Project Name: Newton Medical Building
Project Number: 23-078

ADDENDUM NO. 02

D100
DEMO OVERALL
ROOF PLAN

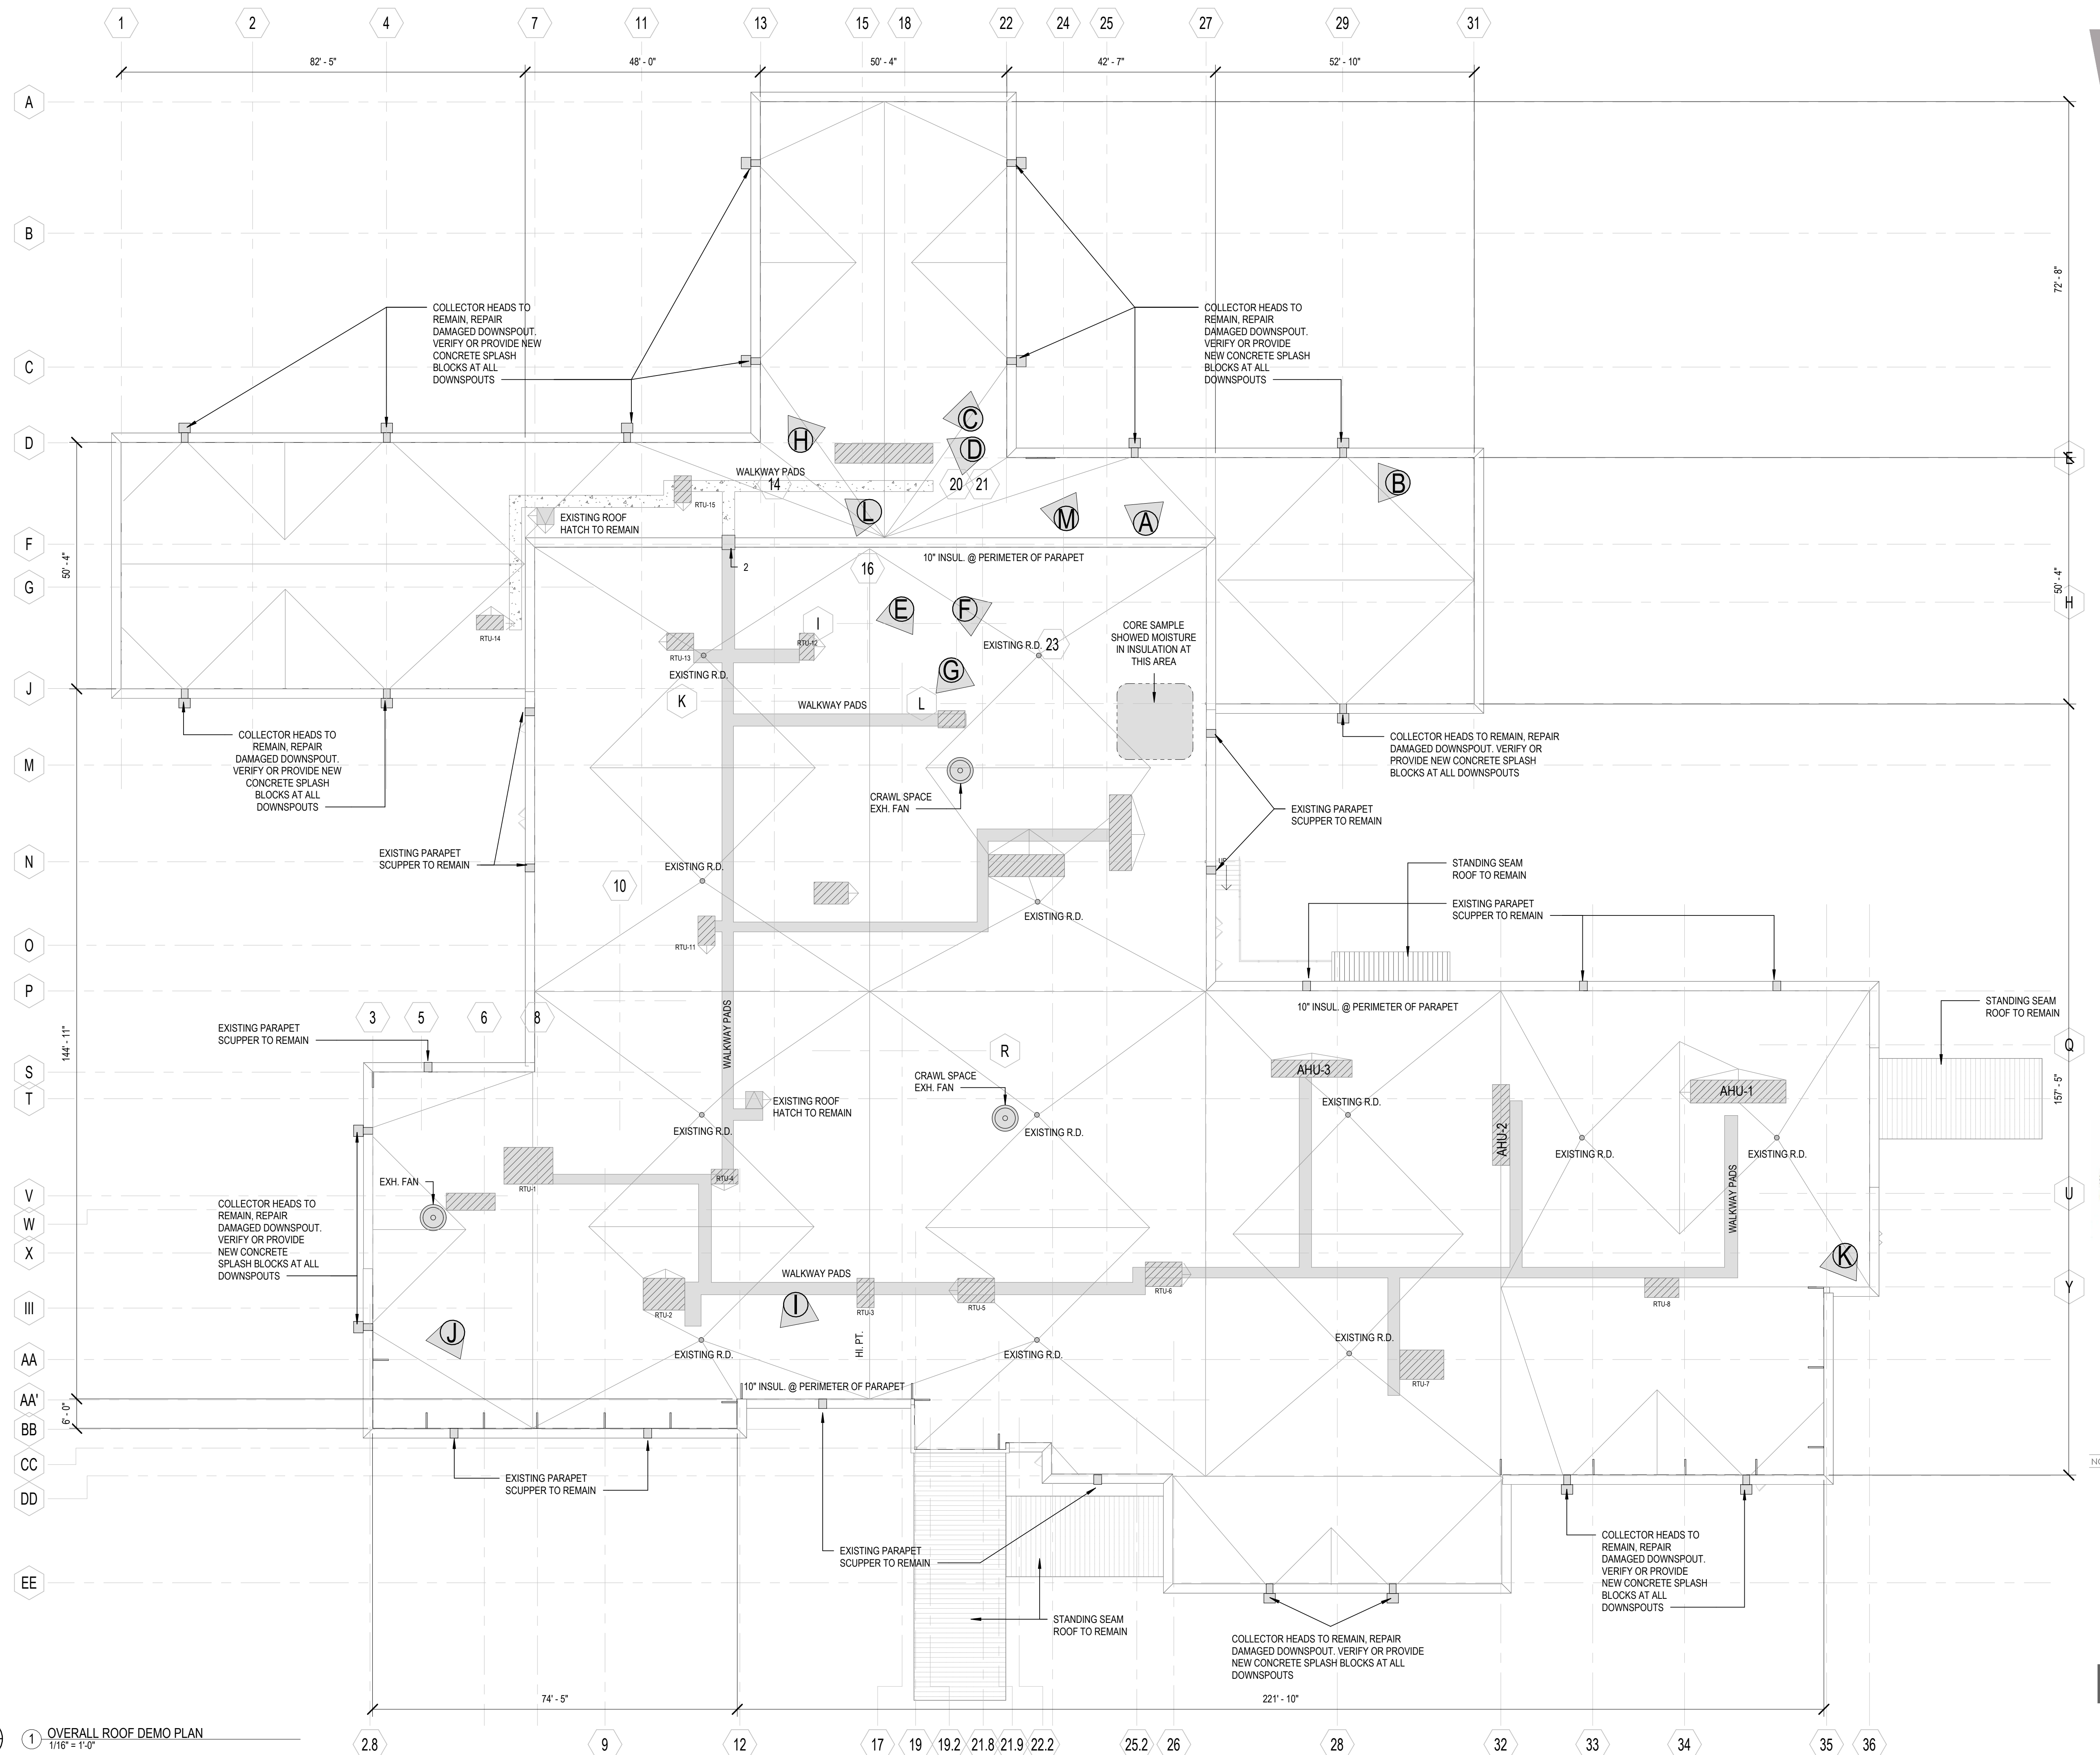
Drawing A101 Roofing Notes states, ‘5. Existing tapered insulation to be replaced up to 10% as required.’
Drawing D110 General Demo Key Notes states, ‘2. ...It is assumed that up to 10% of the existing insulation to be replaced under base bid.’”*
Attached is a revision to drawings D110 and A101 to replace “10%” with “15%” where applicable.

- ITEM NO. 08 DRAWINGS A101 - ROOF PLAN & D100 - DEMO OVERALL ROOF PLAN: REMOVE “10%” AND REPLACE WITH “15%”.

2. REMOVE THE EXISTING ROOF MEMBRANE IN ITS ENTIRETY. EXISTING WET OR DETERIORATED INSULATION TO BE DEMOLISHED AS NEEDED. IT IS ASSUMED THAT UP TO 10% OF THE EXISTING INSULATION TO BE REPLACED UNDER BASE BID.
